CMT #	Page/ Para. #	Comments on DG-1081, SRP	NRC Staff Response
1.	Page 4, 1.1.2 DG-1081	<p>Add the following sentence at the end of the first paragraph of 1.1.2, Defense in Depth:</p> <p>"However, reliance on manual operator actions is acceptable if adequate time and information are available to the operator and if the facility modification results in significant hardware simplification (e.g., elimination of a complex automatic control system)."</p>	<p>The NRC staff believes that the proposed DG language is appropriate. While the simplifications described in the proposed language could be appropriate in limited circumstances, reliance on manual operator actions as a compensation for design deficiencies is generally unacceptable.</p>

**Figure A-1: Measurements of Fission Gas Content in LWR Fuel Rods**

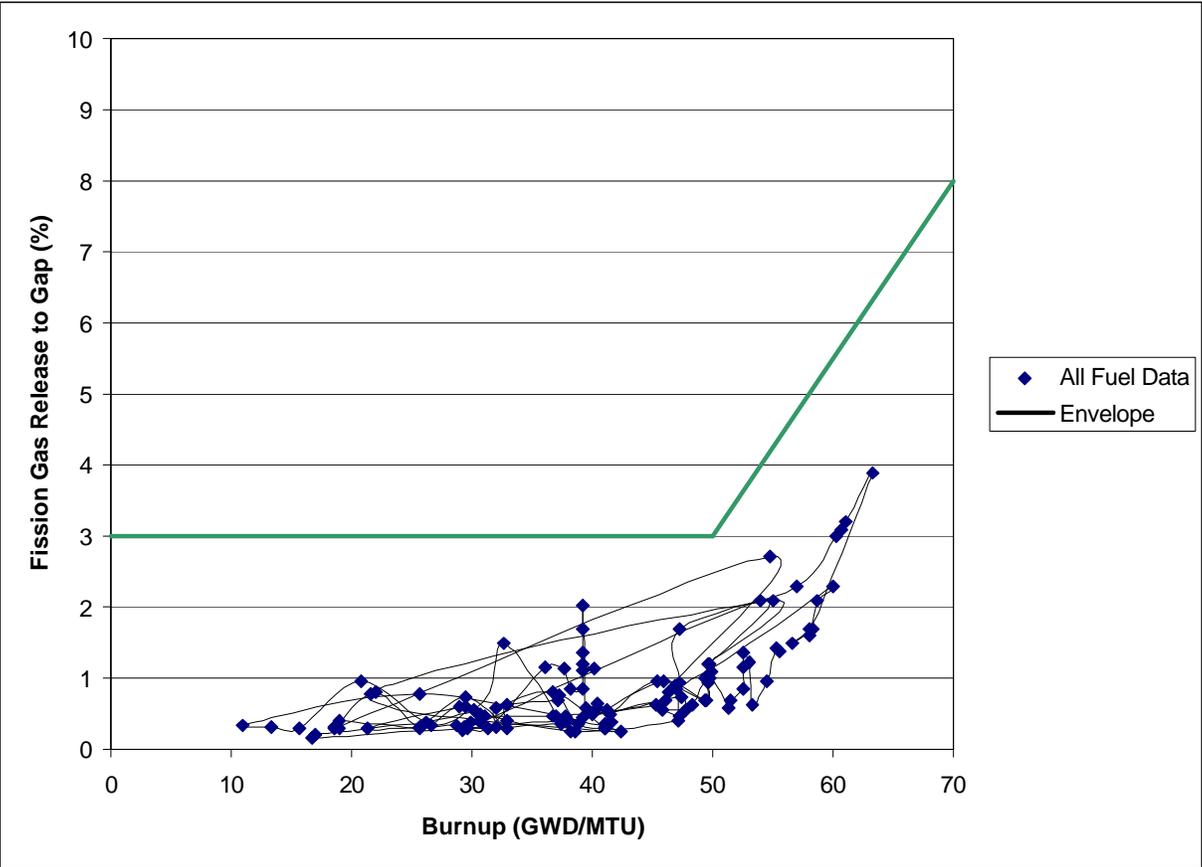
increases with burnup at a rate of about 2.3% per 10,000 MWd/MTU per reference [2]. In the table below, the middle column shows an envelope of the data. The right-hand column of the table shows the industry recommended gap fractions for use in analyzing non-LOCA events. The degree of conservatism of this proposed envelope relative to the data is illustrated in Figure A-1.
